This report, "A Review of the Three Mile Island Unit 1 Control Room from a Human Factors Viewpoint," December, 1980, documents the review which is discussed in "Licensee's Testimony of Patrick S. Walsh, William E. Meek, Herbert Estrada, Jr., Julien M. Christensen and Thomas B. Sheridan in Response to Sholly Contention No. 15 and ANGRY Contention No. V(C) (Control Room Design-Human Factors Engineering)," dated September 15, 1980.

A REVIEW OF THE THREE MILE ISLAND UNIT 1 CONTROL  
ROOM FROM A HUMAN FACTORS VIEWPOINT

December, 1980

FIGURE I  
 TEMPERATURE, HUMIDITY MEASUREMENTS, June 5, 1980

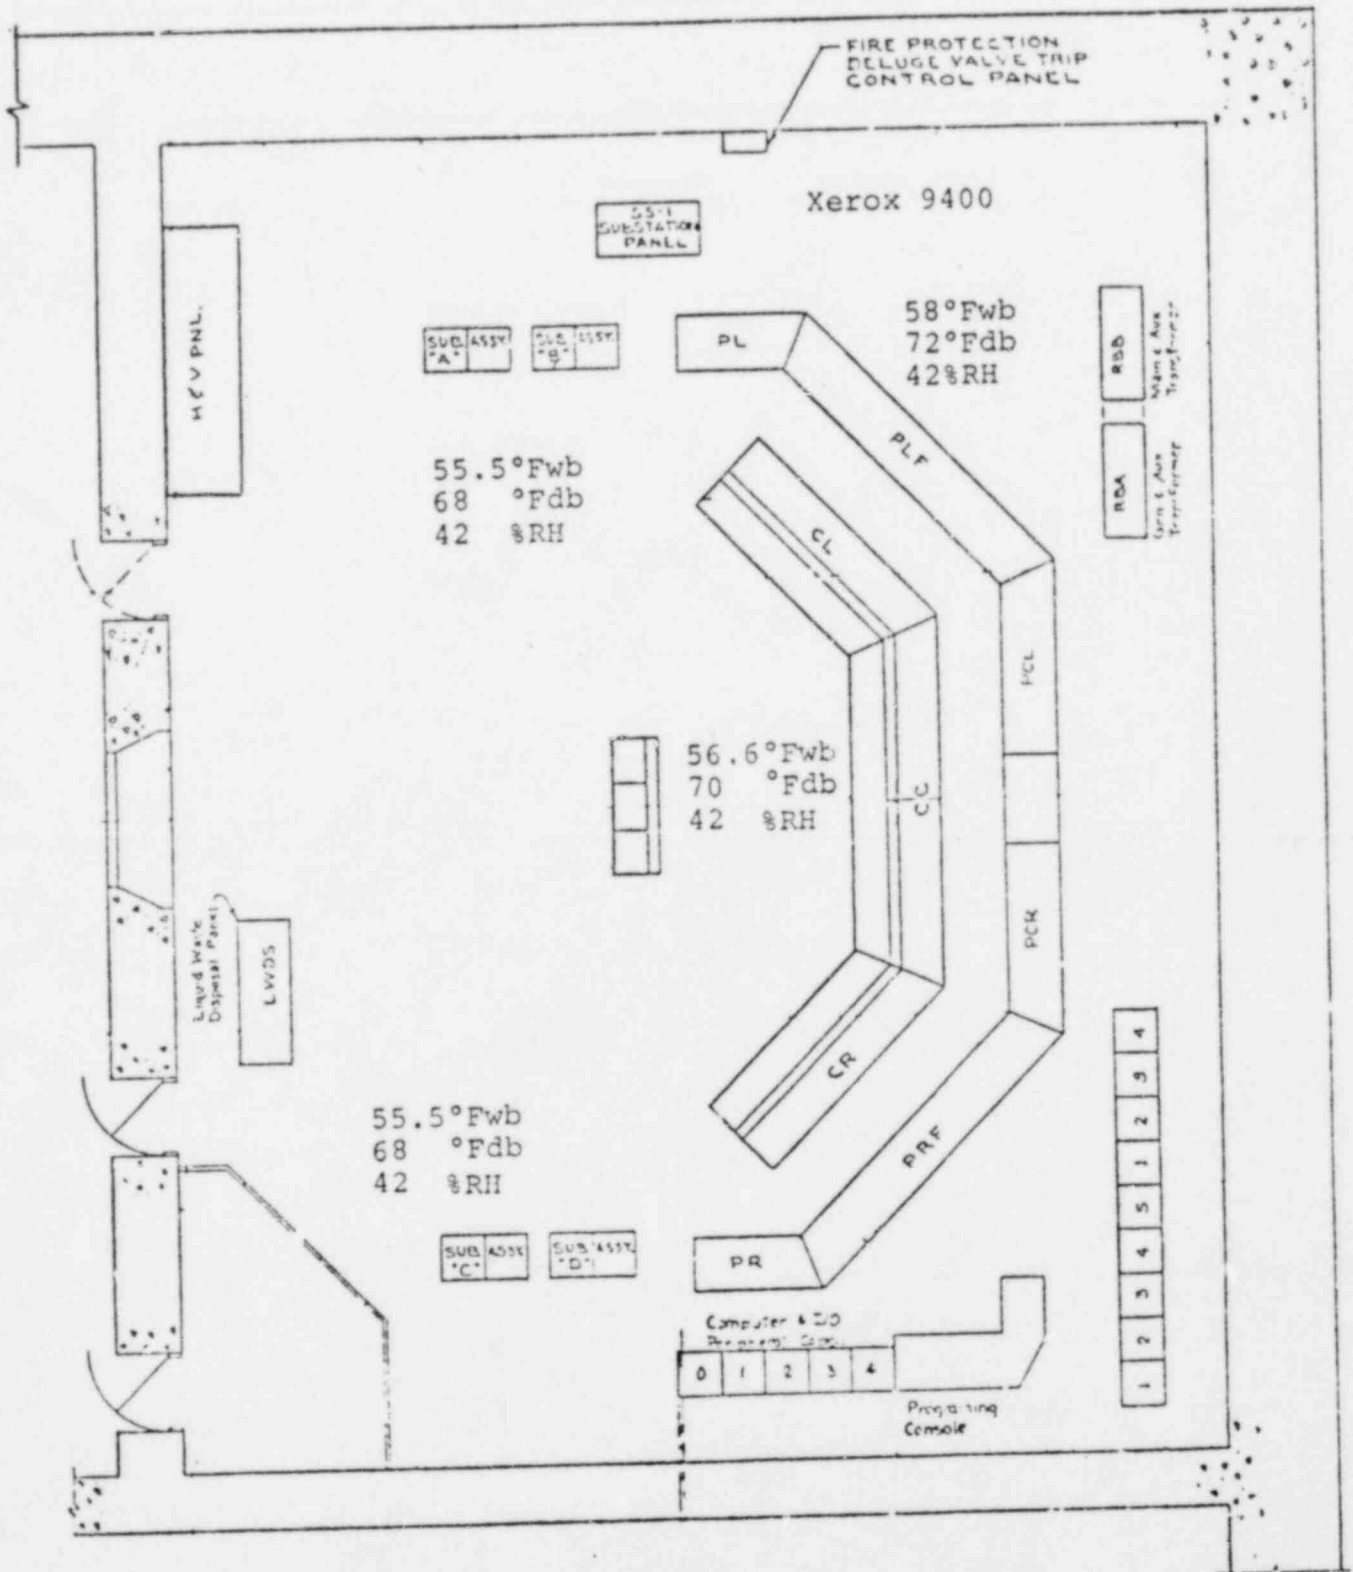
| Findings  | Recommended Action  | Ref. Section                          |
|---|---|---------------------------------------|
| 20. <u>Control Room Environment</u> : low humidity; unnecessary noise; dust accumulation; perception of room as "bright".   | Provide minimum humidity control and dust filtration. Carpet floor to reduce noise, reduce glare, and improve operator comfort and morale.            | III-D.2<br>C-III.A,B,C                |

FIGURE IV  
(See Notes)

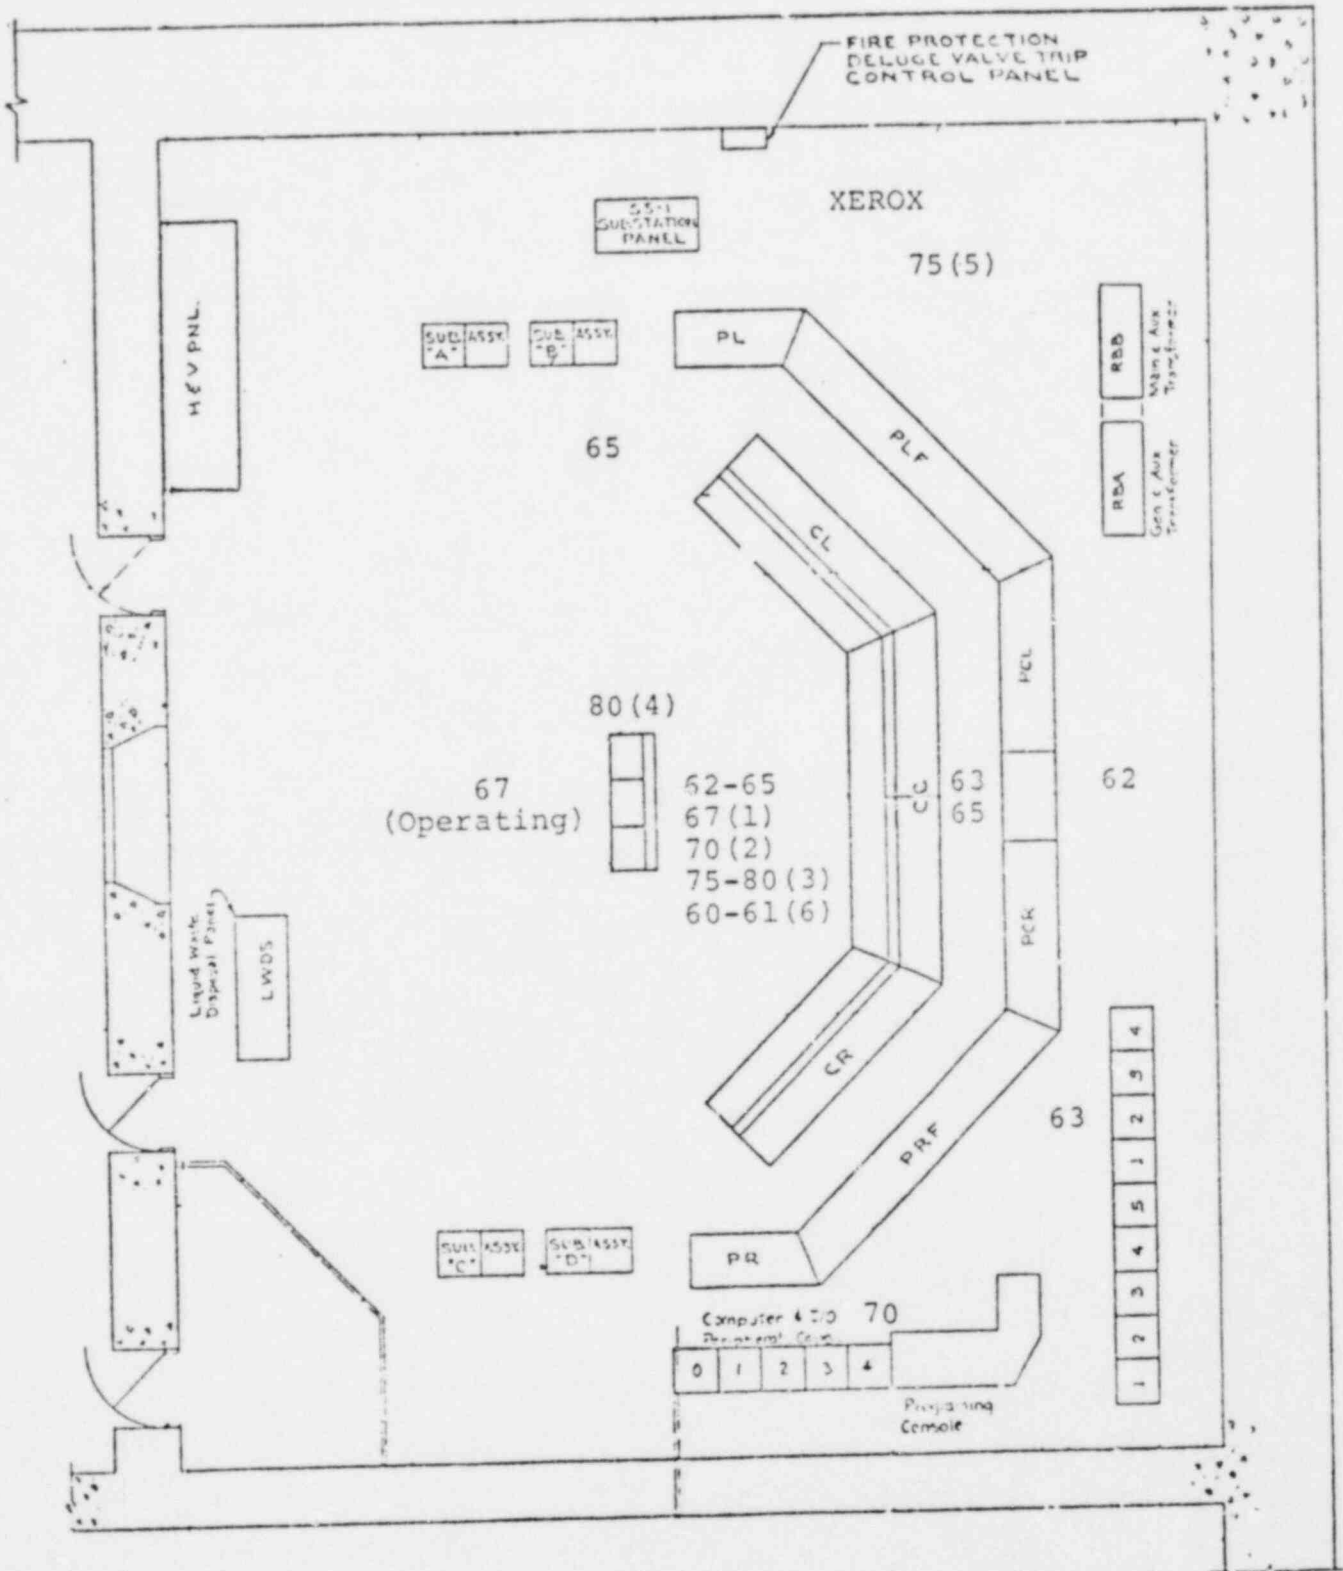
The major concern is whether noise in the control room can, under some conditions, distract or annoy the operators to the extent their performance could be degraded or communications impaired.
